Access Compliance Report

Public Rights-of-Way

(Curb Ramps)

Intersection ID: 12686	Main Street: N_MYERS_ST	Cross Street: PARKSIDE_TERRACE_LN	Location: W
ADA ID: A9AF49D1F287	Ramp Type: ParaDiag	Initial Pass/Fail: Fail	Overall Compliance: No
Severity Score: 13.75			
Codes/Mitigation Info/Possible Solution		Field Measurements/Component Compliance

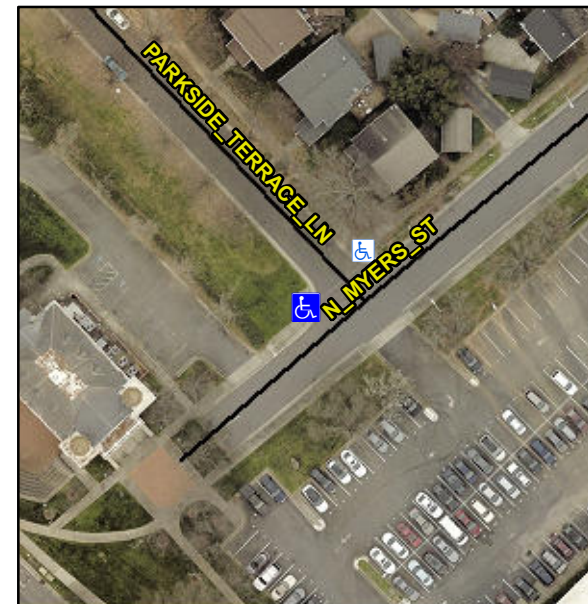
Remove & Replace Curb Ramp With Two New Directional Ramps or Equivalent.

R304.5.3, R304.3.2

Compliance	Description	Data	Compliance	Description	Data
N/A	Ramp Length LT (in)	47.0	N/A	Ramp Length RT (in)	43.0
Yes	Ramp Width LT (in)	72.0	Yes	Ramp Width RT (in)	74.0
Yes	Ramp Slope LT (%)	5.6	No	Ramp Slope RT (%)	10.3
No	Ramp XSlope LT (%)	2.6	Yes	Ramp XSlope RT (%)	0.8
N/A	Landing Length (in)	N/A	N/A	DWS Provided?	N/A
N/A	Landing Width (in)	N/A	N/A	DWS Contrast?	N/A
N/A	Landing Slope (%)	N/A	N/A	DWS Length (in)	N/A
N/A	Landing X Slope (%)	N/A	N/A	DWS Full Width?	N/A
N/A	Landing Curb? (Y/N)	N/A	N/A	DWS Offset (in)	N/A
N/A	Shared Landing?	N/A			
N/A	Gutter Ponding?	N/A	N/A	Gutter Slope (%)	N/A
N/A	Gutter Lip Ht (in)	N/A	N/A	Gutter X Slope (%)	N/A
N/A	Painted X Walk1?	No	N/A	Painted X Walk2?	No
	X Walk 1 Direction	To SE		X Walk 2 Direction	To NE
N/A	X Walk 1 Width (in)	N/A	N/A	X Walk 2 Width (in)	N/A
	X Walk 1 Slope (%)	3.6		X Walk 2 Slope (%)	3.8
	X Walk 1 X Slope (%)	7.6		X Walk 2 X Slope (%)	3.5
N/A	Ramp inside XWalk1?	N/A	N/A	Ramp inside XWalk2?	N/A
